## **Technical Service Bulletin**

MODEL(S) AFFECTED:	T7 AMR Autonomous Rider Scrubber equipped with Operating System 2.8 - 2.10
SUBJECT:	Safety concern - Potential pinch point hazard regarding the automated squeegee lift system when operating machine in manual mode.
PURPOSE:	Squeegee lift system behavior - When operator leaves the seat, the squeegee lift system is triggered to automatically raise off the floor. However, the activation has a 25 second delay before the squeegee lift system is raised. There is a risk of a potential pinch hazard if the operator interacts with the squeegee system during this time span. <b>FOR SAFETY:</b> To prevent a potential pinch point hazard, it is advised to wait until the squeegee lift system is in the raised position before interacting with squeegee system.
NOTES:	Subsequent OS software releases will remove the automated squeegee system lift in both autonomous

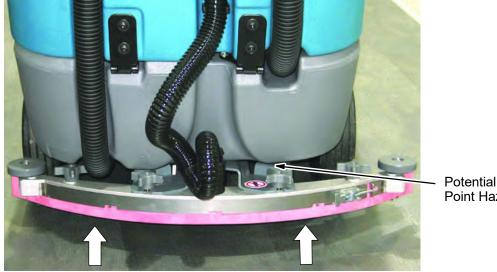
Squeegee Lift System - When operator leaves the seat during manual mode there is a 25 second delay before squeegee begins to lift.

**Potential Pinch** Point Hazard

and manual mode.
